Date: 14 January 2003
To: Technical Committee T10
From: Cris Simpson *cris.simpson@intel.com*
Subject: **SRP-2 Immediate Data**

T10/02-096r0 provided the rationale for including data with SRP write commands: the round trips need to transfer the write data with the existing SRP model reduce performance as latencies increase.

Figure 1 Application model

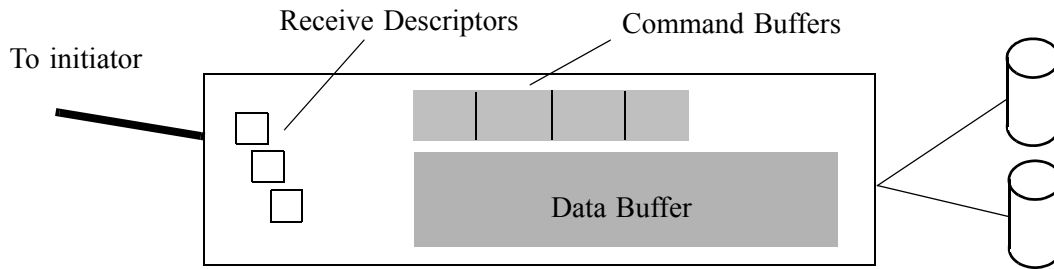
Figure 1 shows a model of an SRP target, with receive descriptors and command and data buffers. In this proposal, the data within the information unit begins at a known offset, allowing receive descriptors to split an incoming information unit into a ‘command part’ placed into a command buffer and a ‘data part’ placed into a data buffer.

There is a cost to the target for supporting immediate data: data buffers must be allocated at the time the receive descriptors are posted. When immediate data is not enabled, data buffers need not be allocated until the target issues the RDMA read operation to fetch the write data. Early allocation increases the time that buffers are allocated, resulting in higher buffer utilization and decreasing the number of commands the target may support at one time.
